SUNDRY NOTICES AND REPORTS ON WELLS
Do not use this form for proposals to drill or to re-enter an abandoned well. Use form 3160-3 (APD) for such proposals.

EOG Resources requests an amendment to our approved APD for this well to reflect a change in casing design as attached.

Well Name: Antietam 9 Fed Com No. 707H

Proposed Wellbore
Revised 1/17/18
API: 30-025-*****

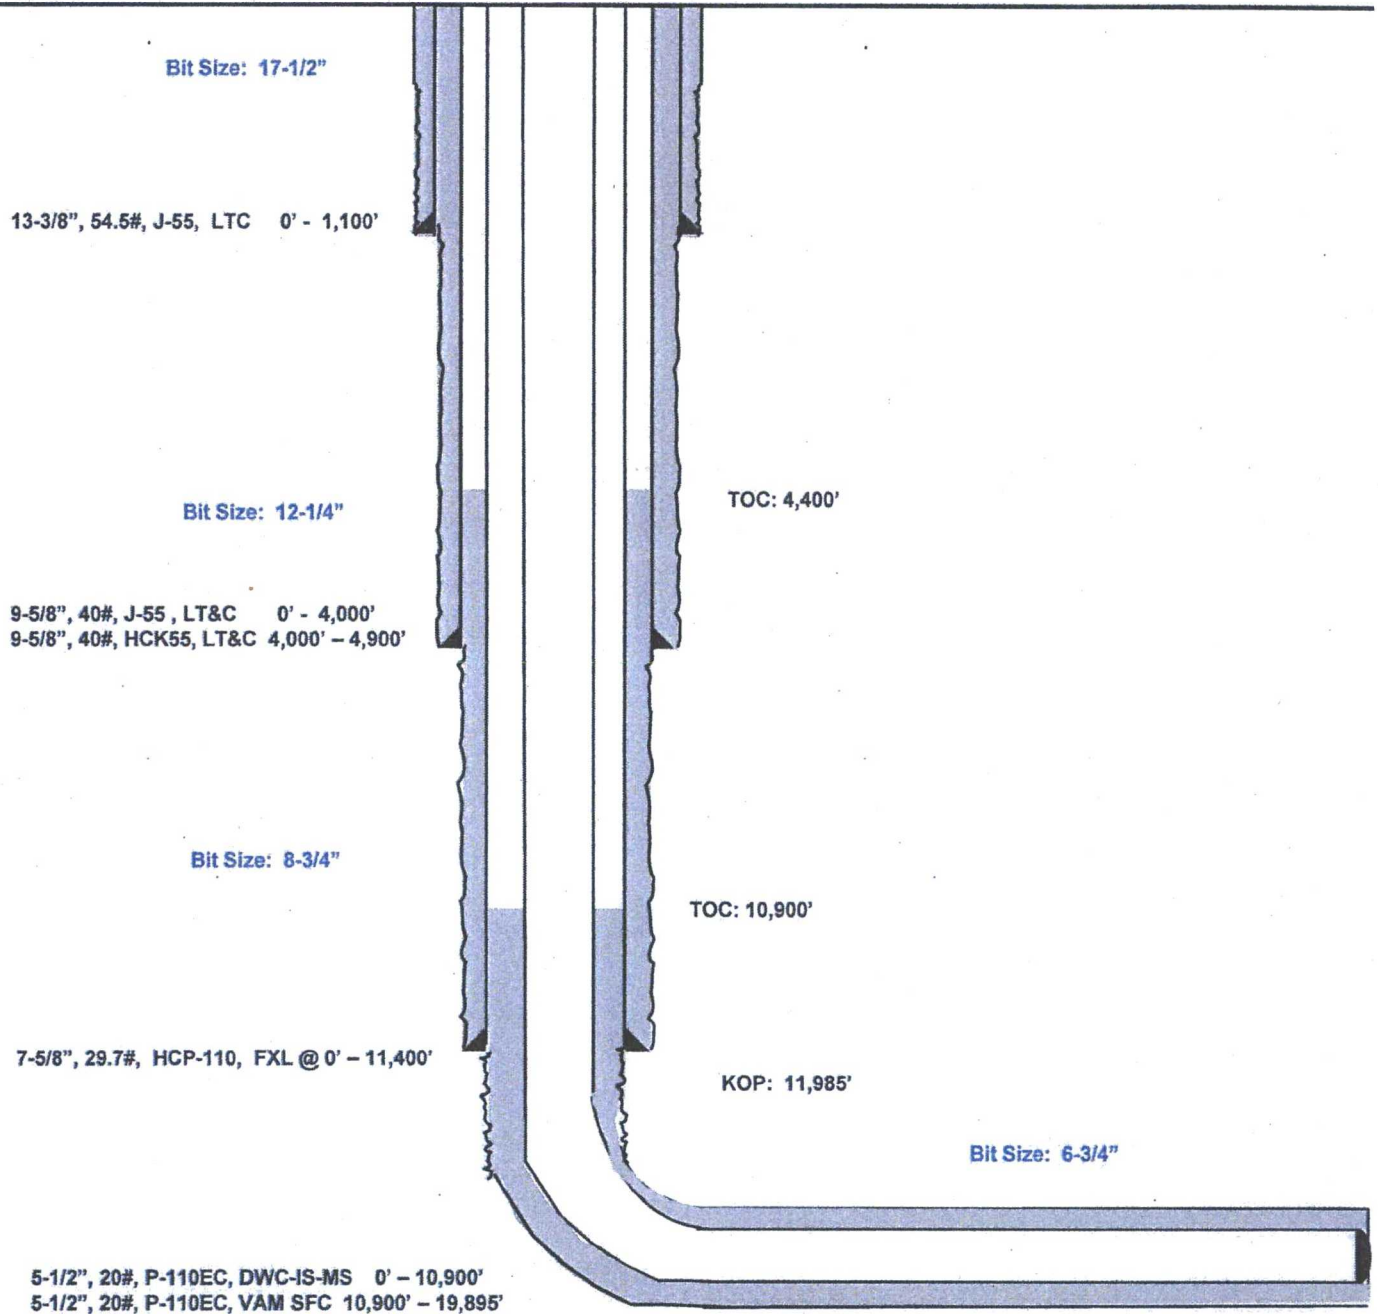
Change to a 4-string casing design.

Hole Size	Interval	Csg OD	Weight	Grade	Conn	DF _{min} Collapse	DF _{min} Burst	DF _{min} Tension
17.5"	0 - 1,100'	13.375"	54.5#	J55	STC	1.125	1.25	1.60
12.25"	0-4,000'	9.625"	40#	J55	LTC	1.125	1.25	1.60
12.25"	4,000' - 4,900'	9.625"	40#	HCK55	LTC	1.125	1.25	1.60
8.75"	0 - 11,400'	7.625"	29.7#	HCP110	FXL	1.125	1.25	1.60
6.75"	0 - 10,900'	5.5"	20#	P110EC	DWC CIS MS	1.125	1.25	1.60
6.75"	0'-19,895'	5.5"	20#	P110EC	VAM SFC	1.125	1.25	1.60

Variance is requested for annular clearance of the 5-1/2" x 7-5/8" to the top of cement.
